UNITED STATES PATENT AND TRADEMARK OFFICE

APPLICATION NO.	FILING DATE	FIRST NAMED INVENTOR	ATTORNEY DOCKET NO.	CONFIRMATION NO.
10/648,586	08/26/2003	Efren M. Lacap	408204	4089

Office Action Summary

DETAILED ACTION

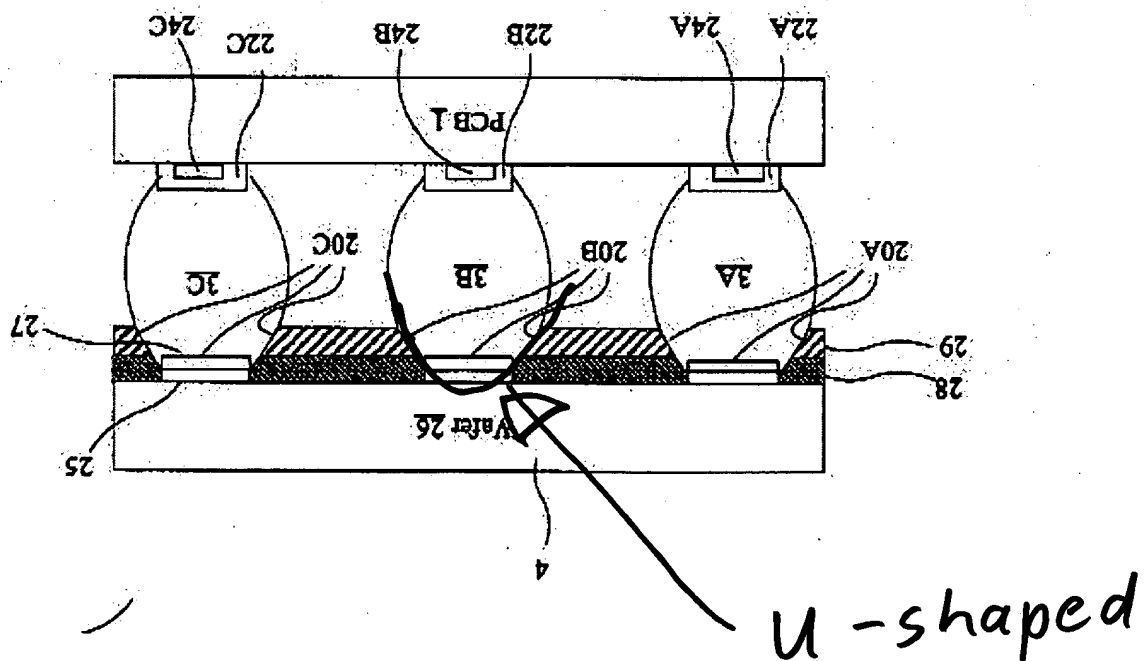
Applicant argues that a solder ball is not a solder bar and cites Webster's Dictionary to support his position. The examiner disagrees. During patent examination, the pending claims must be "given the broadest reasonable interpretation." Applicant always has the opportunity to amend the claims during prosecution, and broad interpretation by the examiner reduces the possibility that the claim, once issued, will be interpreted more broadly than is justified. In re Prater, 415 F.2d 1393, 1404-05, 162 USPQ 541, 550-51 (CCPA 1969). In the instant case, while applicant's definition is proper, it is the examiner's position that applicant's definition is not the broadest reasonable interpretation. As stated previously, DICTIONARY.COM defines "bar" as "a structural or mechanical member." In applying the Prater test by giving the claims its broadest reasonable interpretation, it is the examiner's position that the solder ball of AAPA could be considered a solder bar because, inter alia, it is a mechanical member that assists in supporting the chip (4) on top of the pcb (1).

Applicant again argues that the figure 2 microchip is "already installed." The examiner agrees. Applicant goes on to argue that it does not meet the claim 1 limitation. The examiner disagrees. During patent examination, the pending claims must be "given the broadest reasonable interpretation." Applicant always has the opportunity to amend the claims during

Applicant next argues that the connection pad footprint does not have the claimed geometry. The examiner disagrees. A "U" shape is clearly visible from figure 2 (see below).
